Transportation Engineering Design Standards (TEDS) Exception Request

City File No.:	TED-	2009-151	(To be filled in by City Staff)
Project:		Brakes Plus	
Site Address:		519 Ligrani Lan	e, Grand Junction, CO
Applicant:		Kimley-Horn and	d Associates, Inc.
Representative:		Gabe Krell	
Date:		June 30, 2009	
Parent Project:			<u>/</u>
Project Name:		Mahia Pl	9-151
City File No.:		TED - 200	9-151

Transportation Engineering Design Standards (TEDS) Exception Recommendation Form

Re: TEDS Exception 2009-151– Brakes Plus - Rimrock

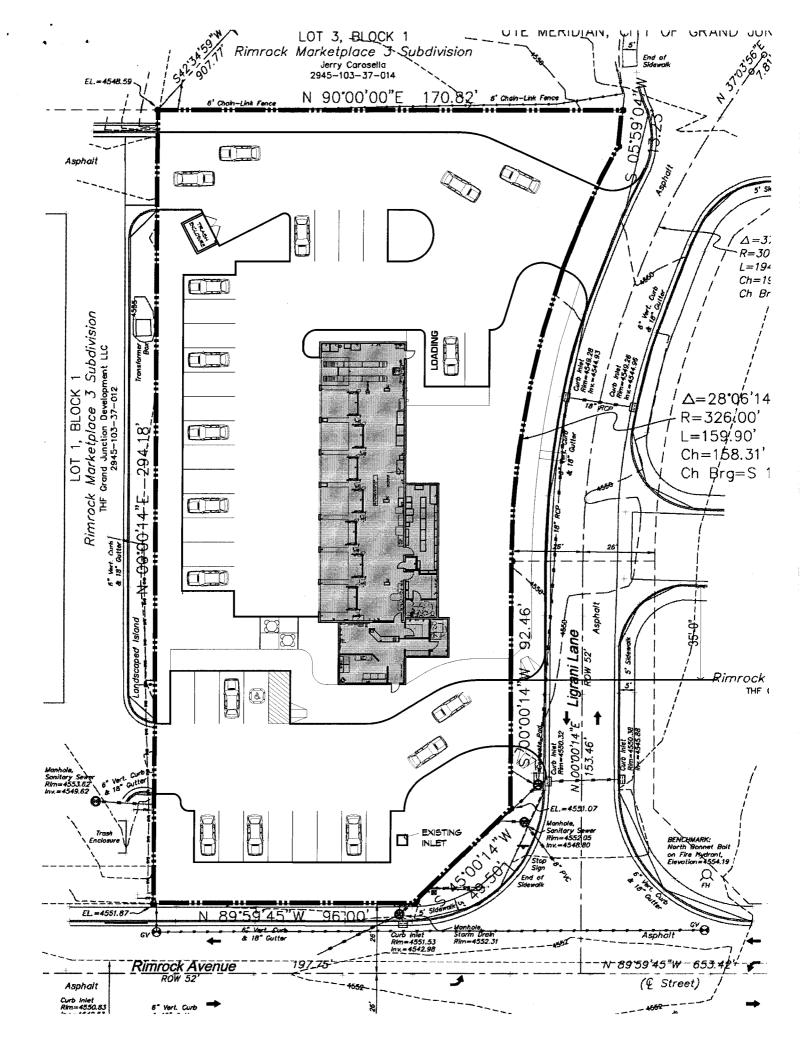
A Brakes Plus is proposed to be located on the northwest corner of the Rimrock Avenue and Ligrani Lane intersection. A TEDS exception is being requested due to not being able to meet the minimum access spacing distance between adjacent driveways (50 feet on local commercial and industrial streets). A driveway exists to another business on the east side of Ligani Avenue (as shown in the attached aerial). The Brakes Plus access is proposed to be located approximately 35 feet south of this driveway as shown in the attached site plan.

We are requesting an exception of 4.1.1 Spacing for accesses as outlined in TEDS. This is due to the proposed driveway being located approximately 35 feet south of the existing access on the east side of Ligrani Lane. Although there is approximately 65 feet spacing to Rimrock Avenue, the proposed Brakes Plus southern access on the west side of Ligrani Lane is not able to be located further south while maintaining the existing curb return radius on the northeast corner of the Rimrock Avenue and Ligrani Lane intersection. Ligrani Lane is a cul-de-sac street with a minimal traffic volume. The TEDS exception would allow an access for patron parking (served by the southern access) separate from the work area (served by the northern access).

- TEDS Exception Request #1: TEDS 4.1.1 Access Spacing. The request is to reduce the spacing between the proposed driveway for Brakes Plus and the existing driveway to the shopping area to the east.
- Comment: The two driveways are offset in the correct direction so there are not conflicting left-turn movements for vehicles turning left from Ligrani Lane into the properties. For left turns exiting the sites the separation will be greater than 50 feet since the exiting vehicles will be on the far sides of the two opposing driveways (61' centerline to centerline offset).

Also, the volume of traffic is anticipated to be low on Ligrani Lane so any traffic conflicts will clear quickly and result in minimal delays.

X Approve as requested.

The TED's Exception Committee has approved your request as submitted.
